TECHNICAL SERVICE BULLETIN Wind Or Whistle Noise From Exterior Mirror(s) At Highway Speed

19-2198 17 June 2019

Lincoln 2016-2018 MKX
2019 Nautilus

Figure 1

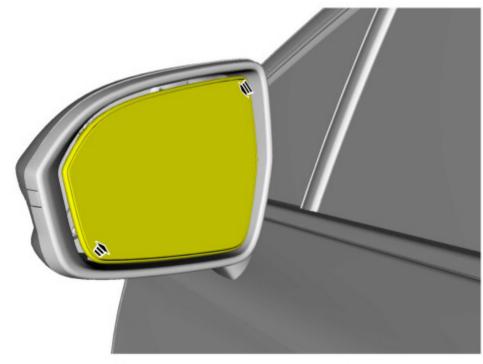
1. Position the exterior mirror glass for access. (Figure 1)

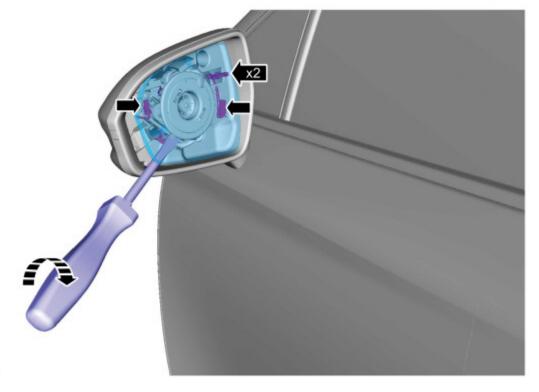
2. Release the mirror glass and disconnect the electrical connectors. (Figure 2)

Figure 3

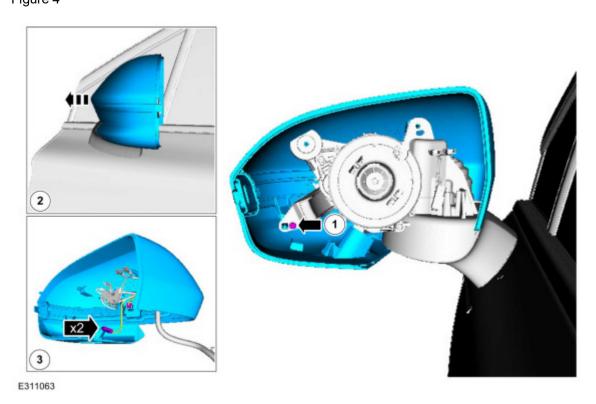
3. Remove the 2 screws and the mirror glass bezel. It is not necessary to remove the mirror motor. (Figure 3)

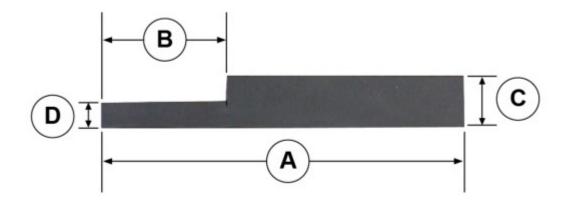
- **5.** Disconnect the 2 electrical connectors.
- **6.** Remove the foam seal tape if present and clean the location shown with isopropyl alcohol. (Figure 5) Figure 5
